Docket No. 52-021 MHI Ref: UAP-HF-12203

Subject: MHI's Response to US-APWR DCD RAI No. 919-6392 Revision 0 (SRP 09.02.02)

Response to Request for Additional Information No. 919-6392 Revision 0

RAI NO.:NO. 919-6392REVISION 0SRP SECTION:09.02.02 - Reactor Auxiliary Cooling Water SystemsAPPLICATION SECTION:09.02.02DATE OF RAI ISSUE:4/10/2012

Figure 2.7.3.3-1 Component Cooling Water System (Sheet 1 of 2)

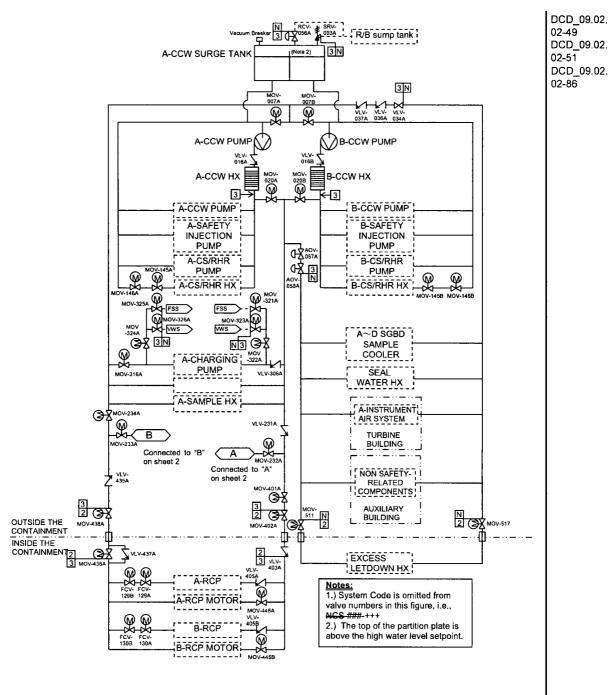
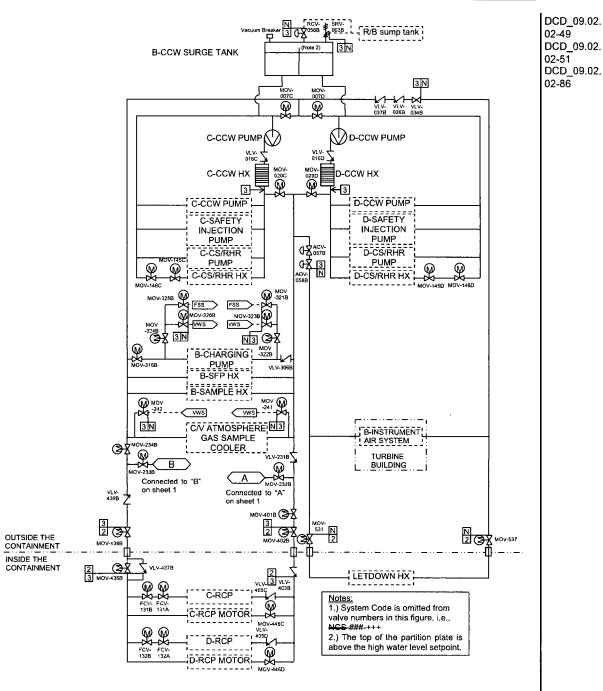
- Table 2.7.3.3-2: Add "CS/RHR heat exchanger CCW outlet 2nd valves", isolation valves MOV-146A, B, C and D.
- Table 2.7.3.3-2: Change the name of MOV-145A, B, C and D from "CS/RHR heat exchanger CCW outlet valves" to "CS/RHR heat exchanger CCW outlet 1st valves."
- Table 2.7.3.3-2: Add "Low CCWP discharge pressure" and "Transfer Closed" to "PSMS Control" and "Active Safety Function," respectively of MOV-145A, B, C and D.
- Table 2.7.3.3-2: Add pressure instruments PT-025, 026, 027,028, 035, 036, 037 and 038.
- Table 2.7.3.3-4: Add the isolation valves MOV-146A, B, C and D.
- Table 2.7.3.3-4: Change the name of MOV-145A, B, C and D from "CS/RHR heat exchanger CCW outlet valves" to "CS/RHR heat exchanger CCW outlet 1st valves."
- Table 2.7.3.3-4: Add pressure instruments (PT-025, 026, 027, 028, 035, 036, 037 and 038.
- Figure 2.7.3.3-1: Add isolation valves (MOV-146A, B, C and D).

Figure 9.2.2-1 Component Cooling Water System Piping and Instrumentation Diagram (Sheet 3 of 9)

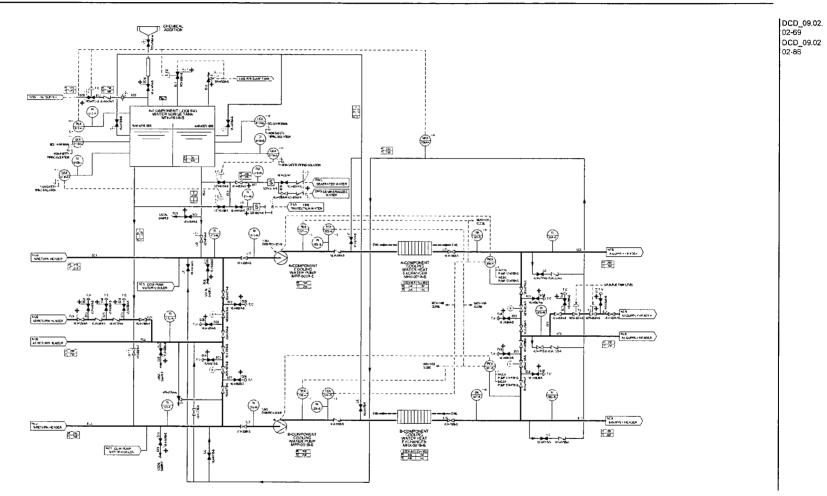
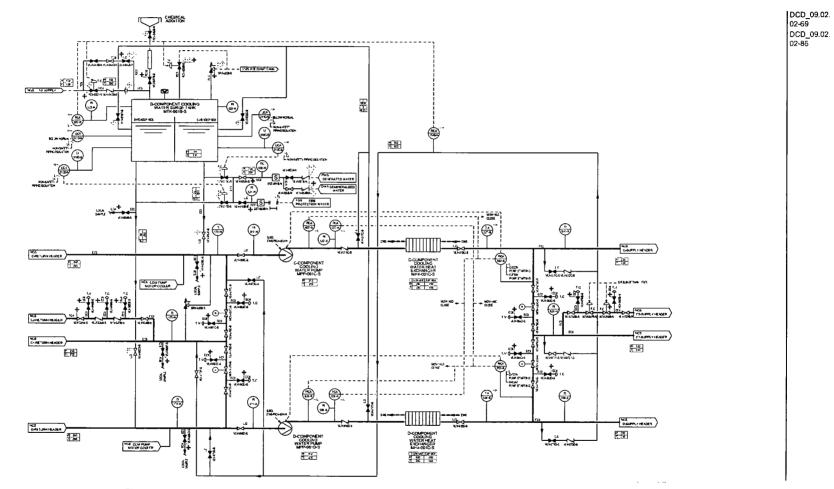
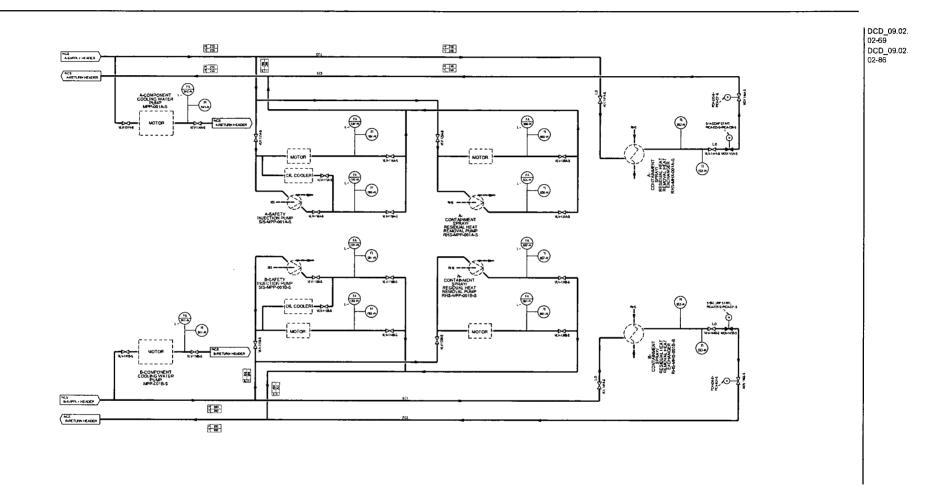
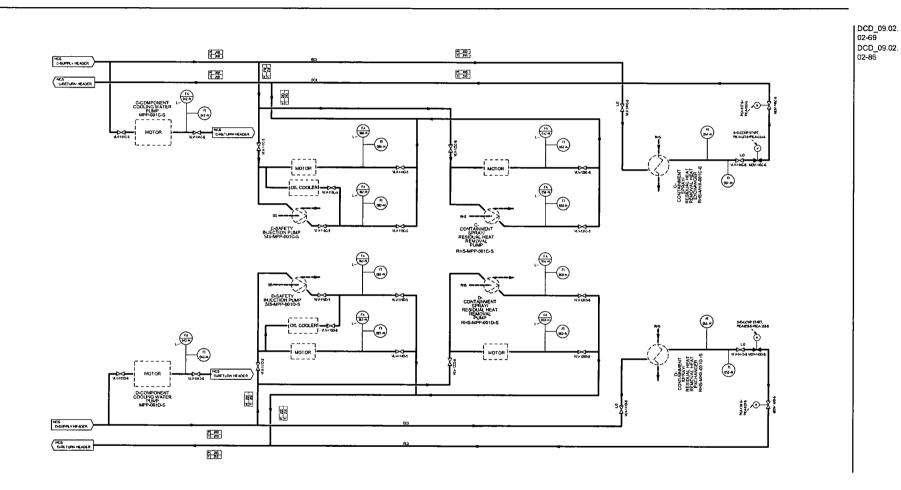
- Table 9.2.2-7: Add isolation valves MOV-146A, B, C and D.
- Figure 9.2.2-1: Add isolation valves MOV-146A, B, C and D and pump discharge pressure instruments PT-025, 026, 027, 028, 035, 036, 037 and 038 and valve closure interlock.

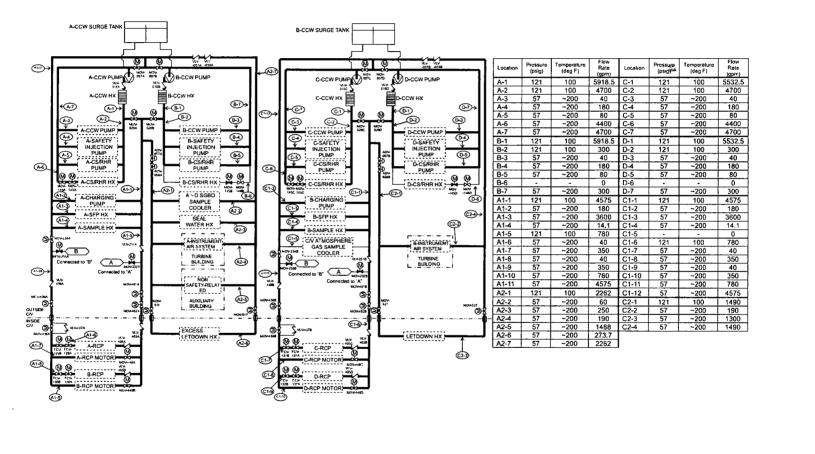
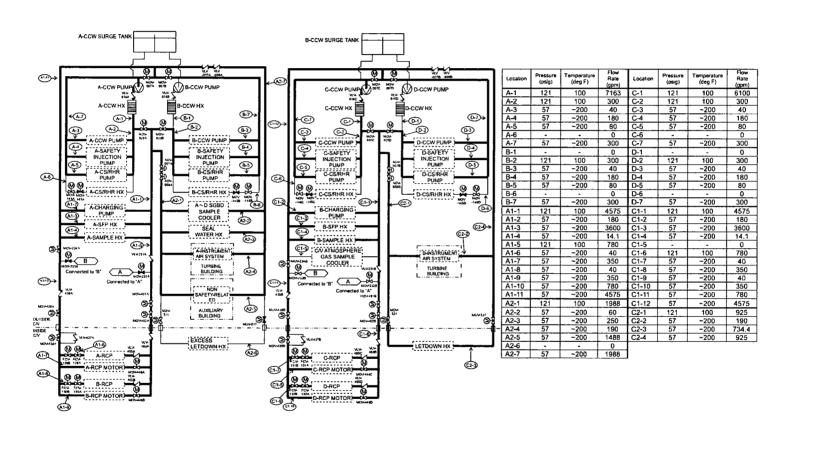
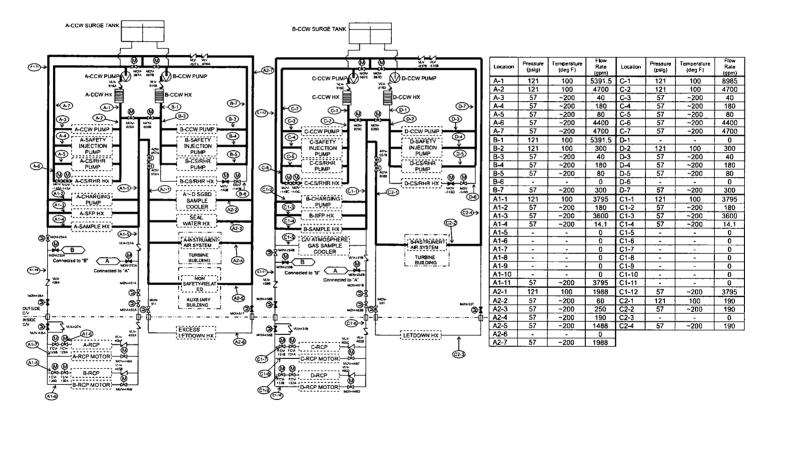
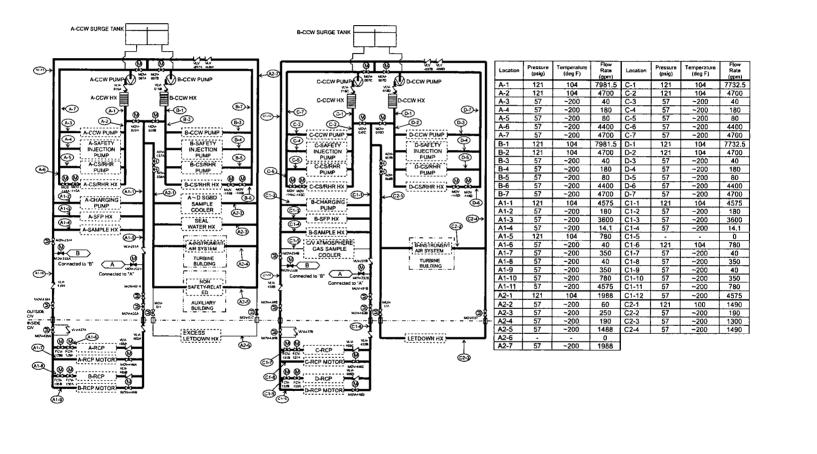
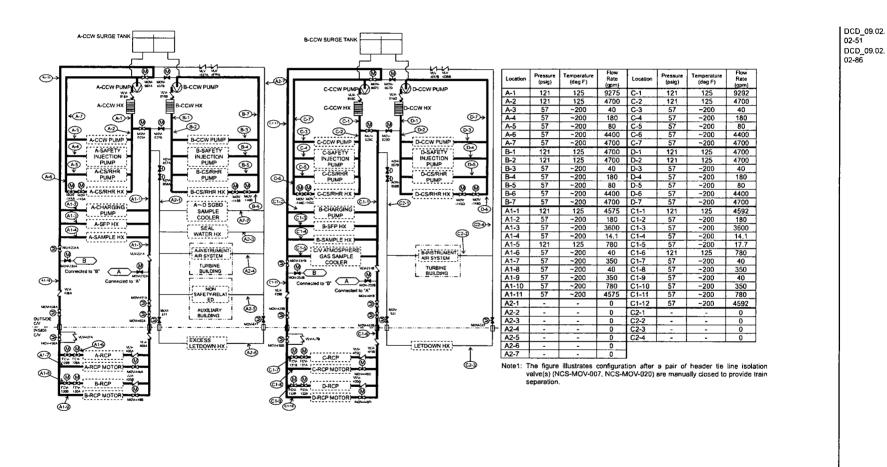
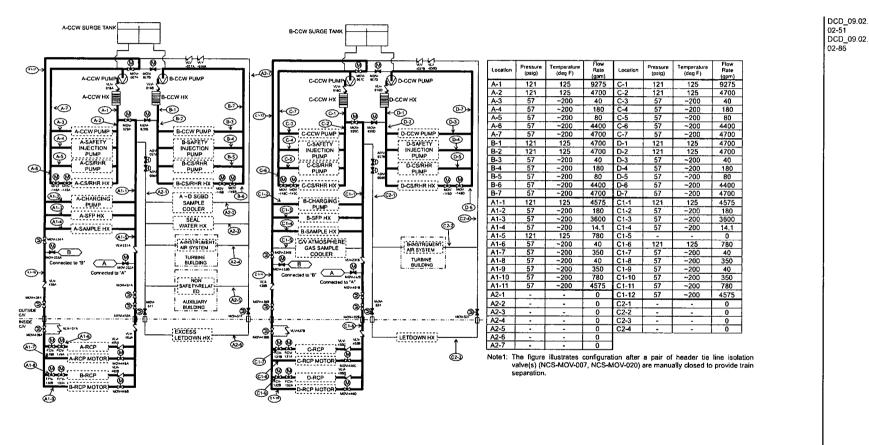
- Figure 9.2.2-2: Add the isolation valves MOV-146A, B, C and D.
